R44 SERVICE LETTER SL-69

R66 SERVICE LETTER SL-29

SUBJECT: C627-6 Five-point Harness Assembly Lower Strap

EFFECTIVITY: R44-series and R66 Helicopters equipped with C627-6 Five-point Harness Assemblies delivered prior to 15 February 2019. Also, spare harness assemblies shipped prior to 15 February 2019.

FIGURE 1

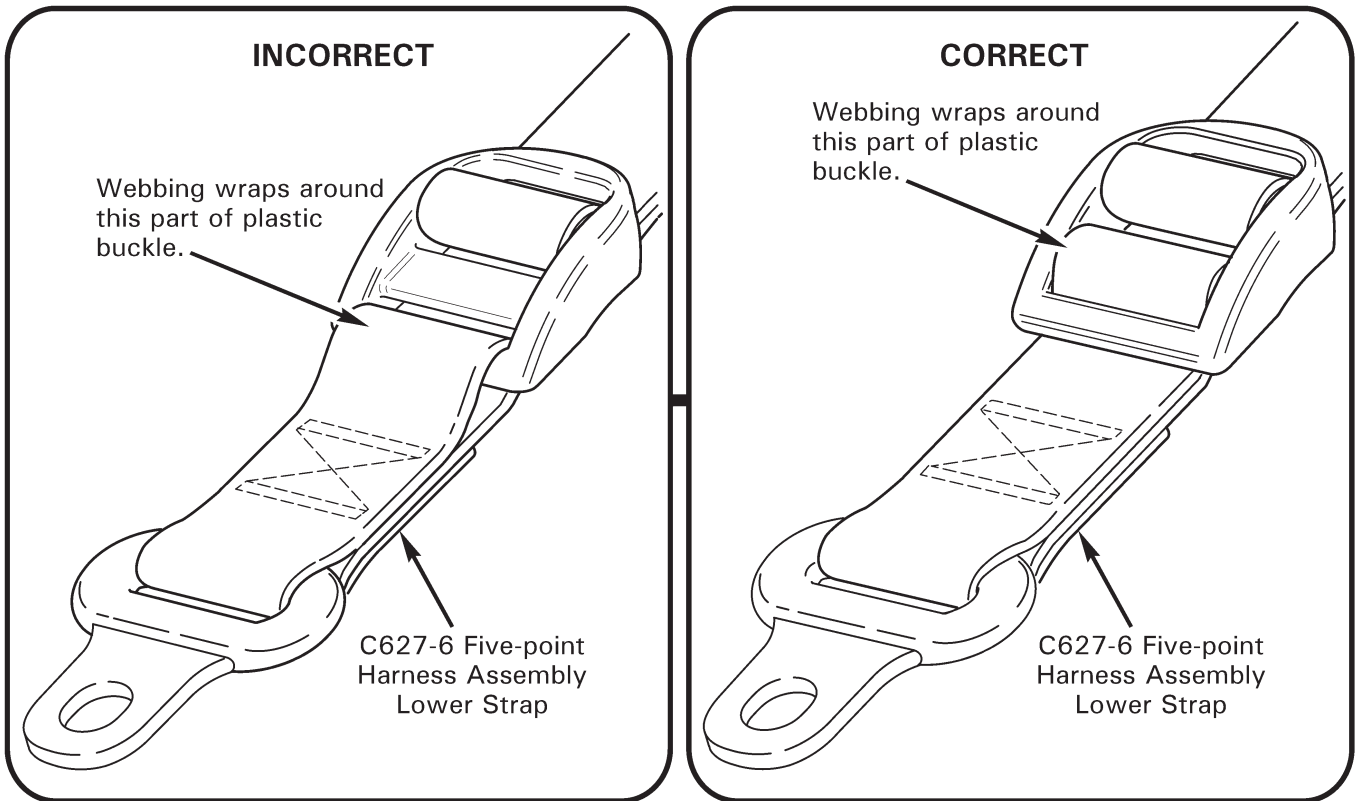
BACKGROUND: RHC has determined that the plastic adjusting buckle on the lower strap of C627-6 Five-point Harness Assemblies may have the webbing routed improperly. As a result, tightening the adjustment may crack the plastic buckle. Incorrect parts should be replaced to ensure that proper adjustment is available to the occupants.

1. Refer to Figure 1. If lower strap of C627-6 Five-point Harness Assembly is assembled incorrectly, order one AmSafe p/n 5134-2010111747 Lower Strap from RHC Customer Service.
2. Refer to Figure 2. Remove incorrect lower strap and install correct lower strap using existing hardware as shown. Verify security.
